**SUBMITTAL OF PLANS FOR CAPPING THE REMAINDER OF VAULT ONE,
Z-AREA SALTSTONE FACILITY (IWP-217) (U)**

Design Change Package (U)

DCP No. C-DCP-Z-93001	Classification <input checked="" type="checkbox"/> U <input type="checkbox"/> UONI <input type="checkbox"/> Other	Rev. 7
------------------------------	-------------------------------------------------------------------------------------------------------------------	---------------

Revision 7 of this DCP is issued in response to C-DCF-Z-00005, which requests several modifications to the existing cap design for Saltstone Vault No. 1. A partial disposition of C-DCF-Z-00005 was provided in revisions 4, 5 and 6 of this DCP. For design modifications to complete the capping of cells B through F, see pages 2 through 9 of this DCP.

SALTSTONE VAULT #1 ISOMETRIC

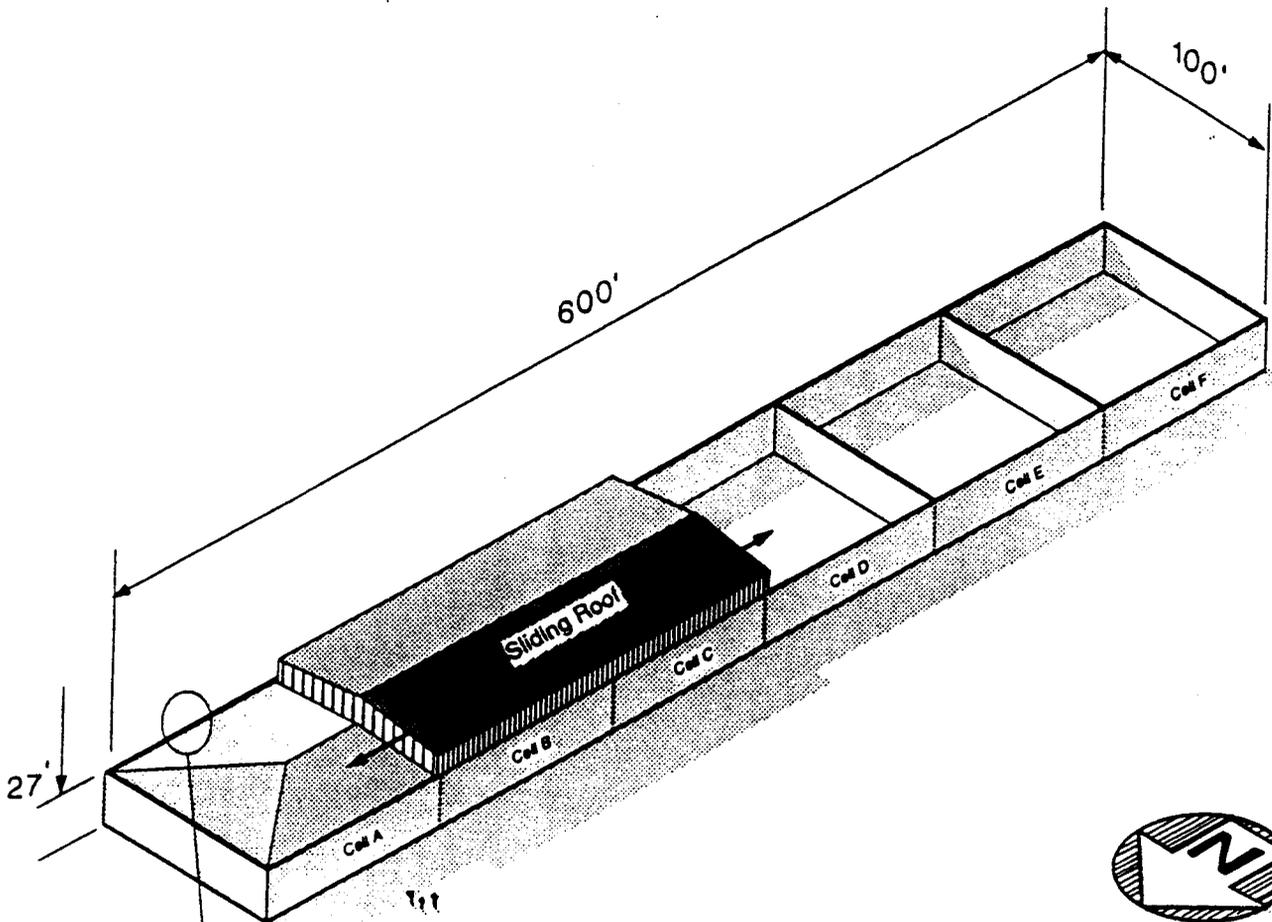
See Detail 1 for an enlargement of this area.

DETAIL

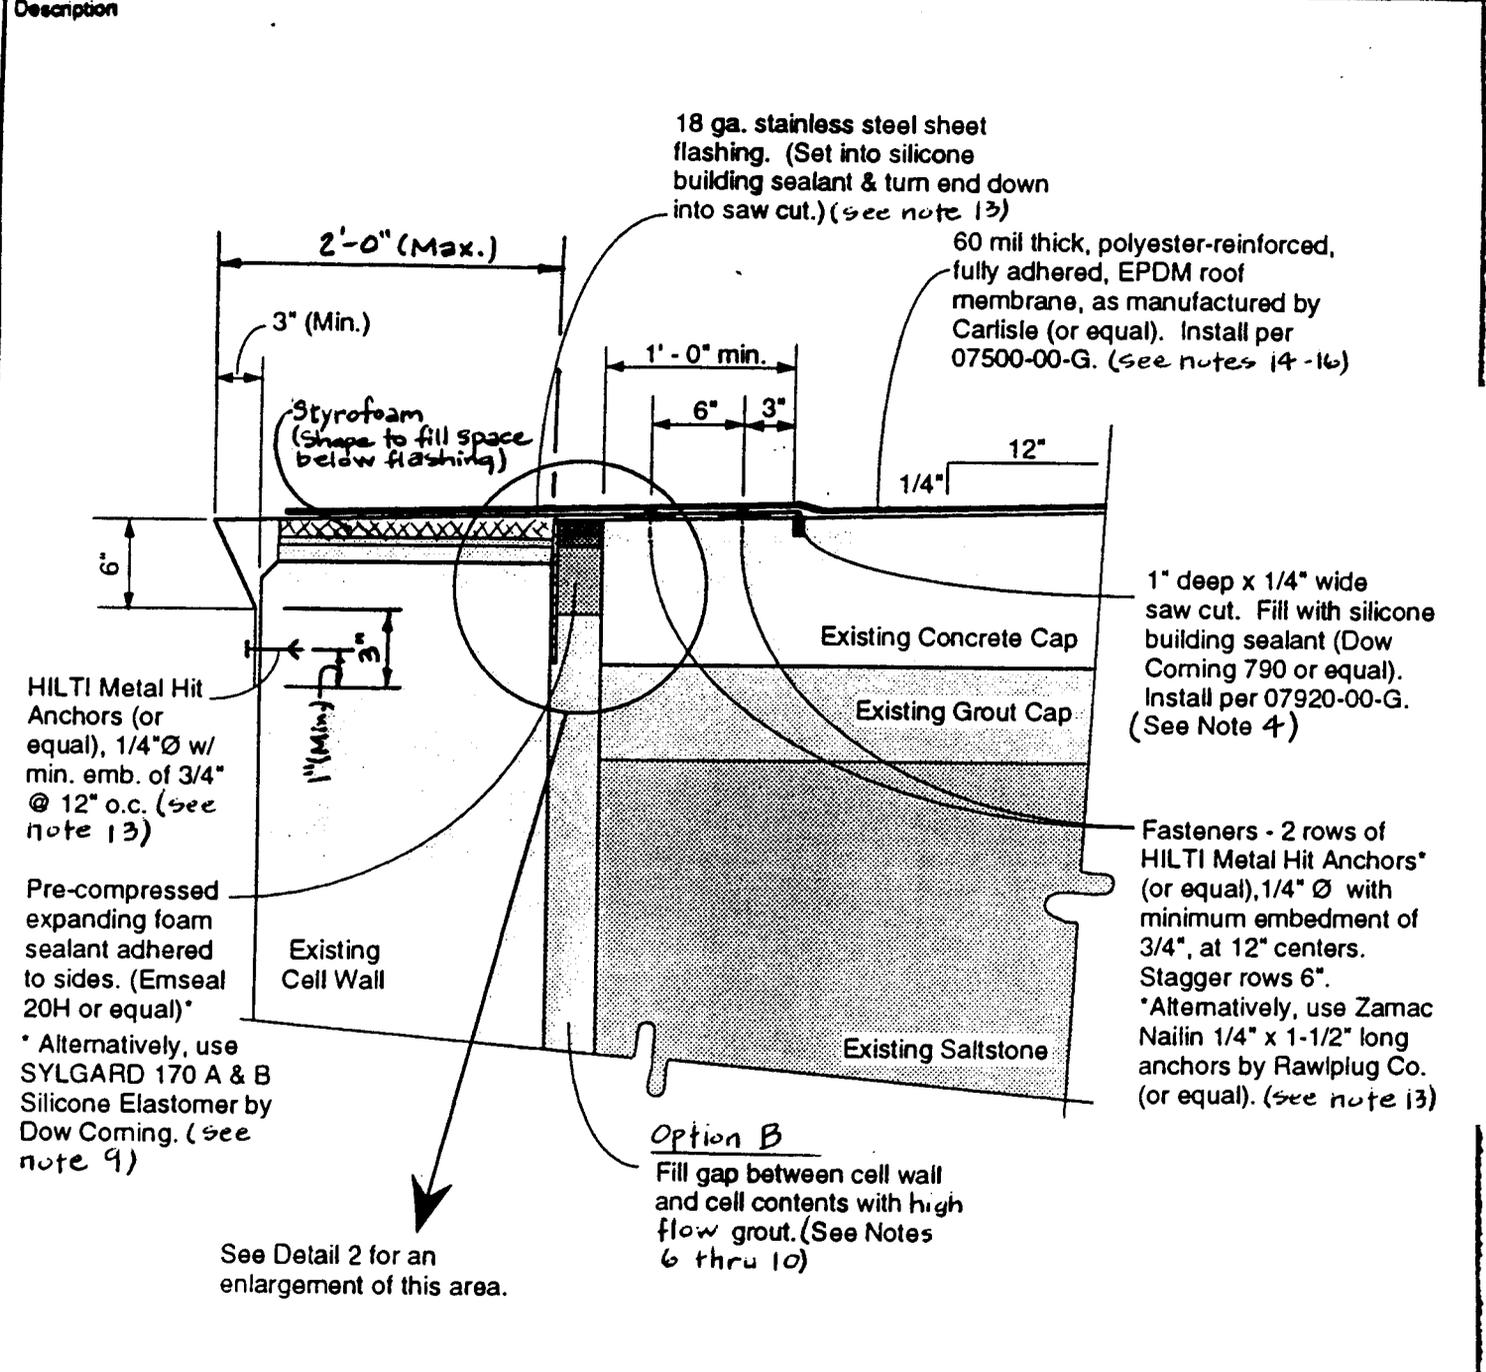
Since the original design for capping cell A of Saltstone Vault No. 1, as shown on drawing C-CC-Z-0010, has been changed due to lessons learned during the construction phase of cell A, the remaining cells (B through F) need a new design.

The capping of Cells B through F shall be completed in accordance with Drawing No. C-CC-Z-0010, sketches on pages 2 through 4 of this DCP, and with the requirements listed below.

There are two options provided. **Option A assumes there is essentially no gap between the vault wall and the interior grout/concrete layers. Option B assumes that there is a gap.** (Note: If Option A or Option B are not shown with a note, then the note applies to both options).

3. Place the 6" reinforced concrete layer in accordance with Drawing No. C-CC-Z-0010. **Option A:** Place a 2" x 5-1/2" expansion joint strip and a 2" wide x 1/2" deep (max.) filler strip (on top), wrapped in a plastic bond-breaker sheet, at the edge of this layer. These 2" wide strips shall be placed flush with the inside face of the cell wall and up to the top of the existing vertical embedded plate.

DETAIL

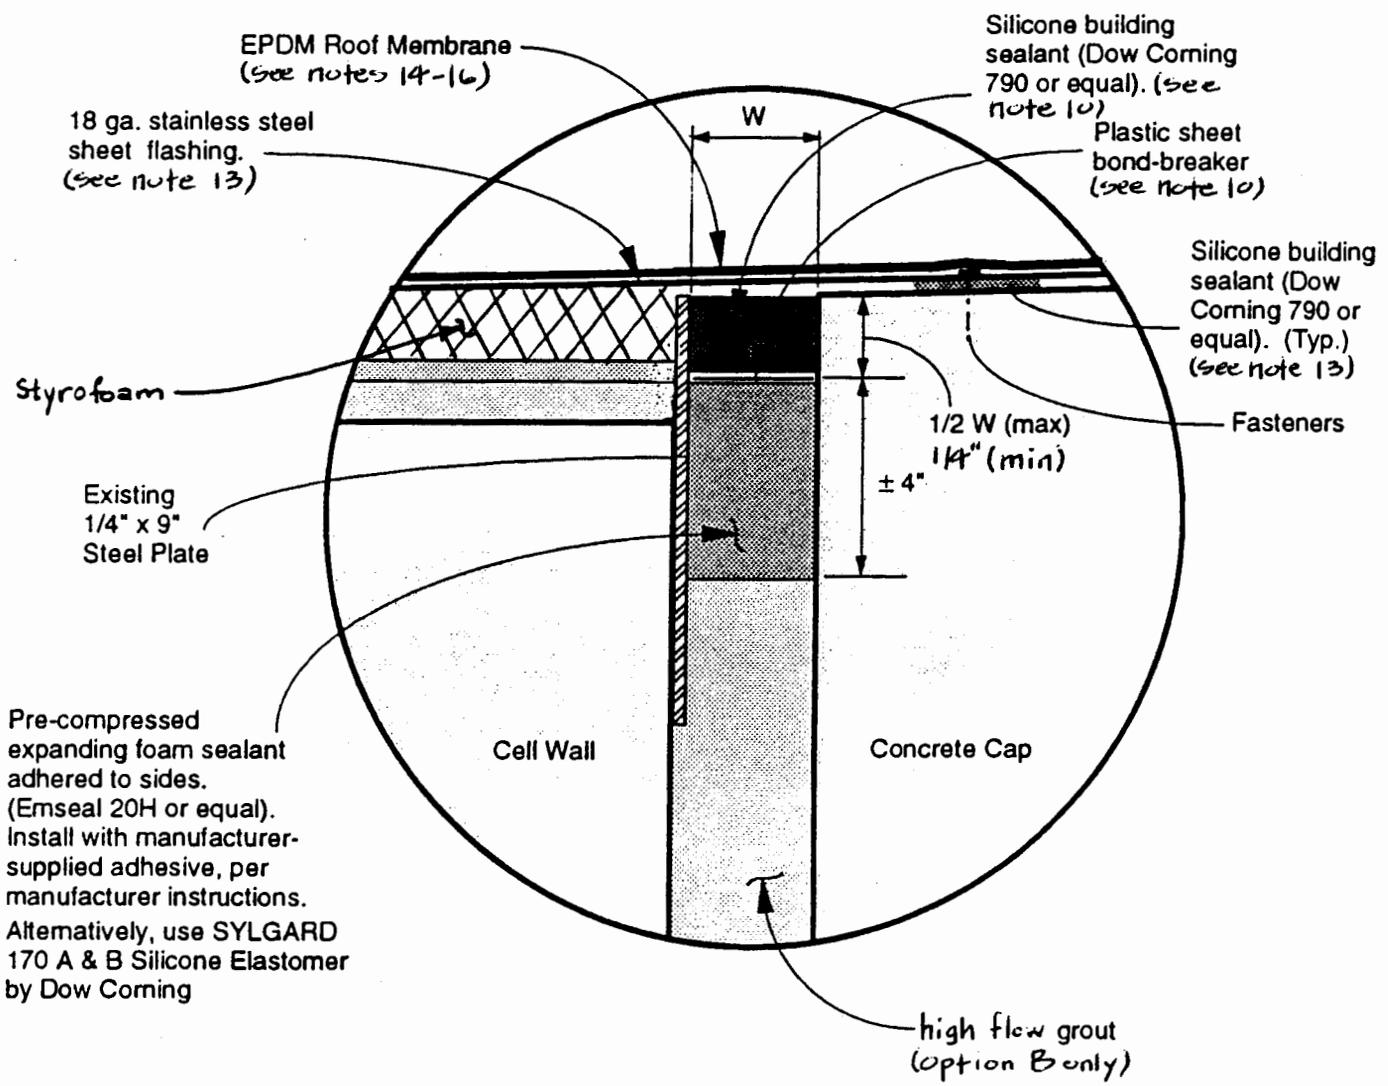
Pre-compressed expanding foam sealant adhered to sides. (Emseal 20H or equal). Install with manufacturer-supplied adhesive, per manufacturer instructions. Alternatively, use SYLGARD 170 A & B Silicone Elastomer by Dow Corning

9. **Option B:** In the gap between the clean grout/reinforced concrete layers and the existing vault wall, install Emseal 20H expanding foam strips (or equal). Alternatively, SYLGARD 170 A & B silicone elastomer by Dow Corning may be used. Install in accordance with manufacturer's instructions. For Emseal, use manufacturer-supplied adhesive on both sides of the gap. Use appropriately sized material for width of gap.

10. **Option B:** Insert plastic bond-breaker sheet on top of expanding foam strips (or existing expansion joint material) prior to installing the single component silicone building sealant. Sealant shall be Dow Corning 790 silicone building sealant (or equal). Depth of sealant shall not exceed 1/2 the width of the gap width. Ensure placement of bond-breaker sheet does not prevent adherence of sealant to sides of gap.
